Access Compliance Report

Public Rights-of-Way

Intersection ID: 30054	Main Street: DAY_LILLY_LN	Cross Street: SOUTHWIND_DR	Location: W
ADA ID: F35511510CF3	Ramp Type: Perp	Initial Pass/Fail: Fail	Overall Compliance: No
		Severity Score: 25

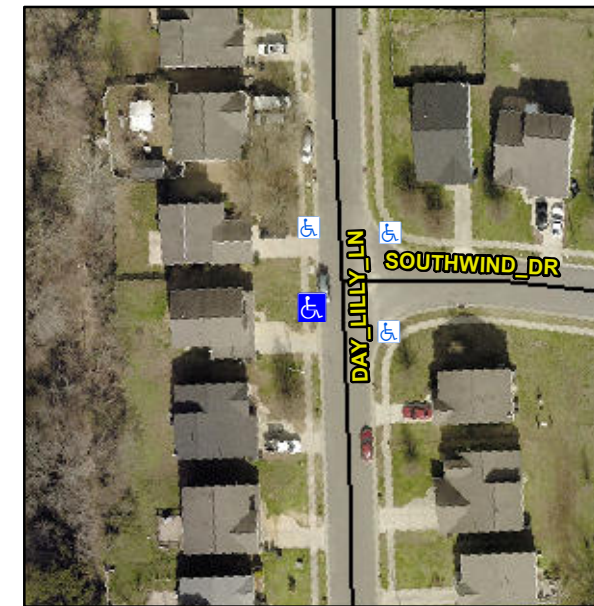
R304.2.2

Compliance	Description	Data	Compliance	Description	Data
N/A	Ramp Length (in)	46.5	No	Ramp Slope (%)	12.4
Yes	Ramp Width (in)	48.0	Yes	Ramp XSlope (%)	1.4
N/A	Flare Type LT	N/A	N/A	Flare Type RT	N/A
N/A	Flare Slope LT (%)	N/A	N/A	Flare Slope RT (%)	N/A
N/A	Flare Traversable LT?	N/A	N/A	Flare Traversable RT?	N/A
N/A	Landing Length (in)	N/A	N/A	DWS Provided?	N/A
N/A	Landing Width (in)	N/A	N/A	DWS Contrast?	N/A
N/A	Landing Slope (%)	N/A	N/A	DWS Length (in)	N/A
N/A	Landing X Slope (%)	N/A	N/A	DWS Full Width?	N/A
N/A	Landing Curb? (Y/N)	N/A	N/A	DWS Offset (in)	N/A
N/A	Shared Landing?	N/A			
N/A	Gutter Ponding?	N/A	N/A	Gutter Slope (%)	N/A
N/A	Gutter Lip Ht (in)	N/A	N/A	Gutter X Slope (%)	N/A
N/A	Painted X Walk1?	No	N/A	Painted X Walk2?	N/A
	X Walk 1 Direction	To SE		X Walk 2 Direction	N/A
N/A	X Walk 1 Width (in)	N/A	N/A	X Walk 2 Width (in)	N/A
	X Walk 1 Slope (%)	2.6		X Walk 2 Slope (%)	N/A
	X Walk 1 X Slope (%)	0.9		X Walk 2 X Slope (%)	N/A

Remove & Replace Entire Ramp.
